PLANNING
14 AUG 2008
FOR ACTION

Option 1
Drawing No. 02

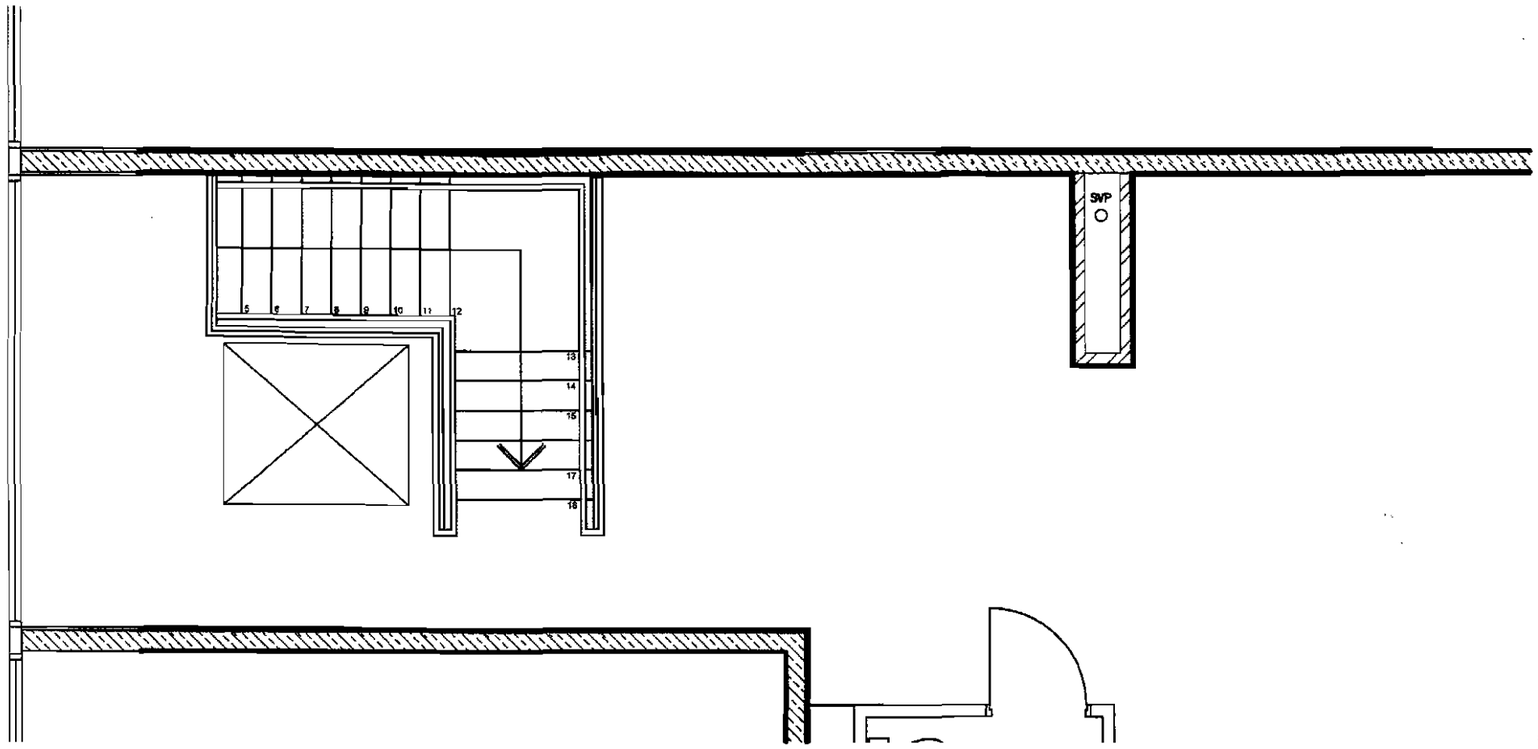
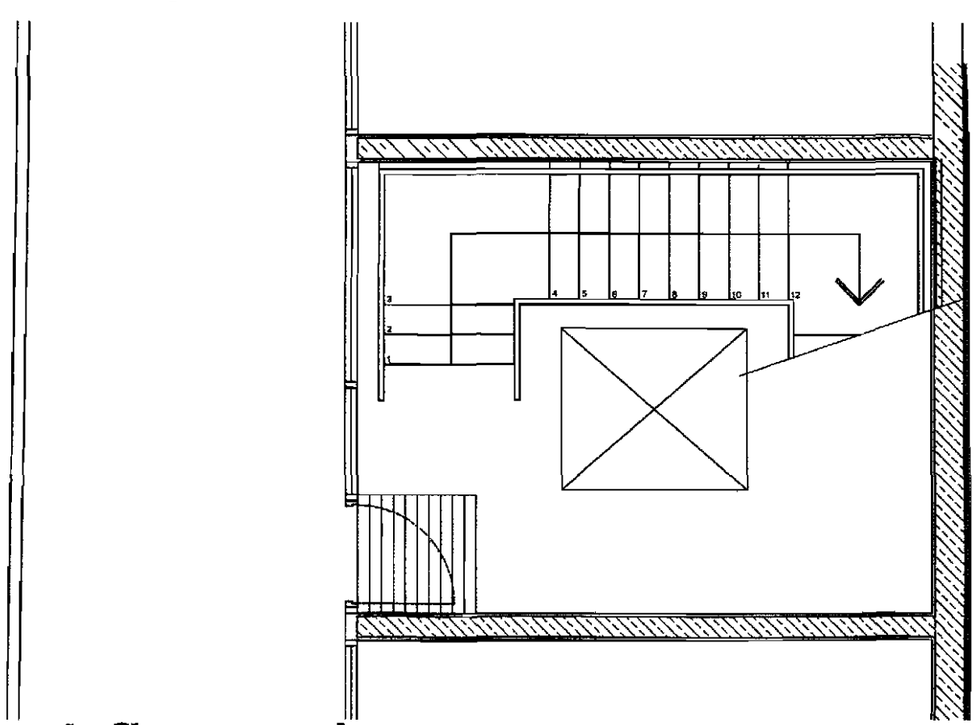
No reception space

Poor access to lift that does not conform to building regs

Stair conforms to abulant disabled regulations
